# 1990 Corvette: Service Bulletin: SIR Revised Code 42 Chart

**Number:** 90-229-9

**Subject:** Service Manual Update - SIR Revised Code 42 Chart

**Model Year:** 1990 Y Car

## CODE 42

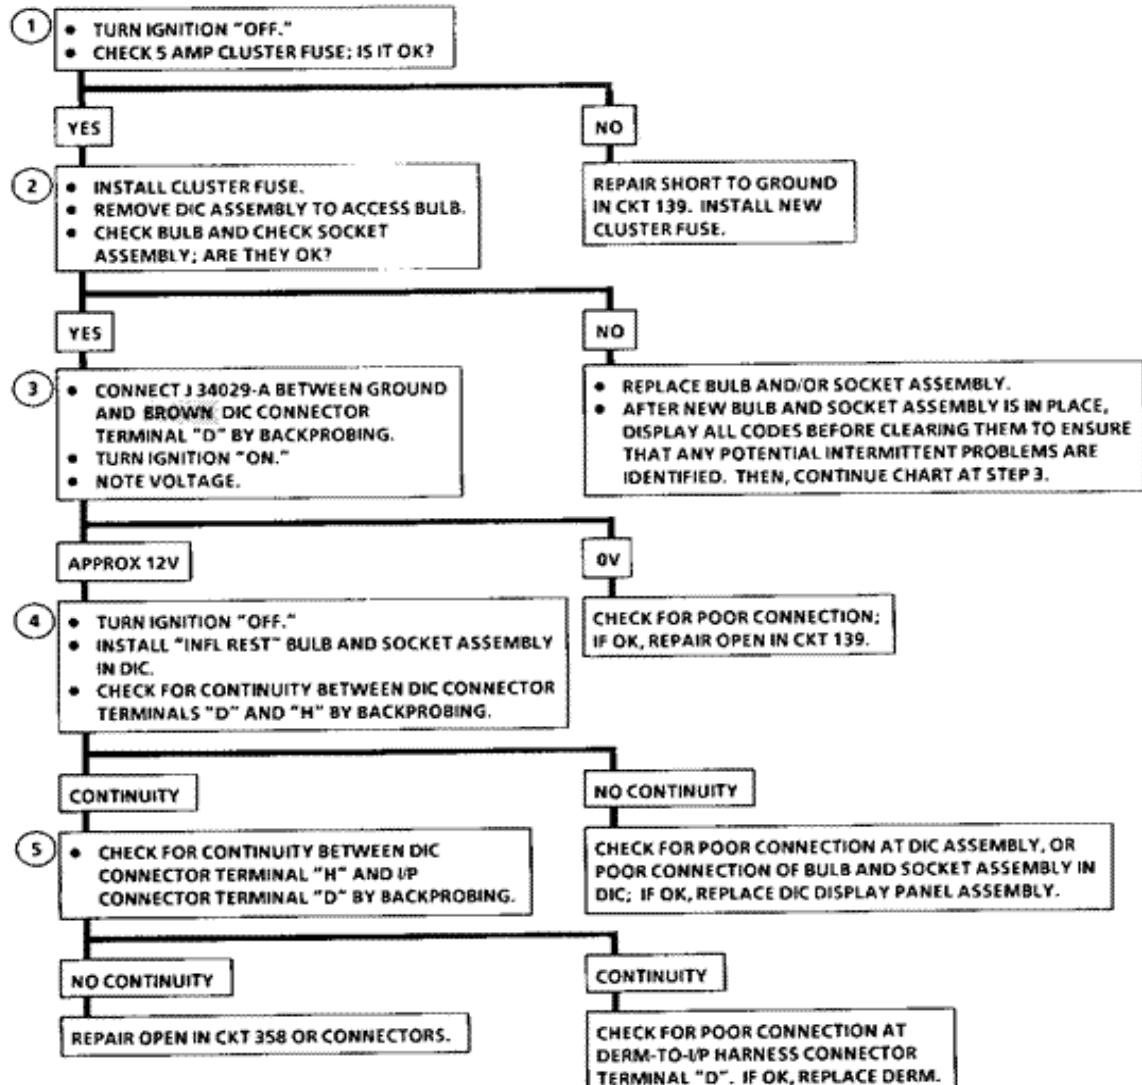
This bulletin serves to revise the Code 42 Chart on page 9J-A-43 in Section 9J-A "Supplemental Inflatable Restraint" in the 1990 "Y" Service Manual.

The blue connector referenced in the chart, step 3, should be a brown connector.

Revised art is attached.
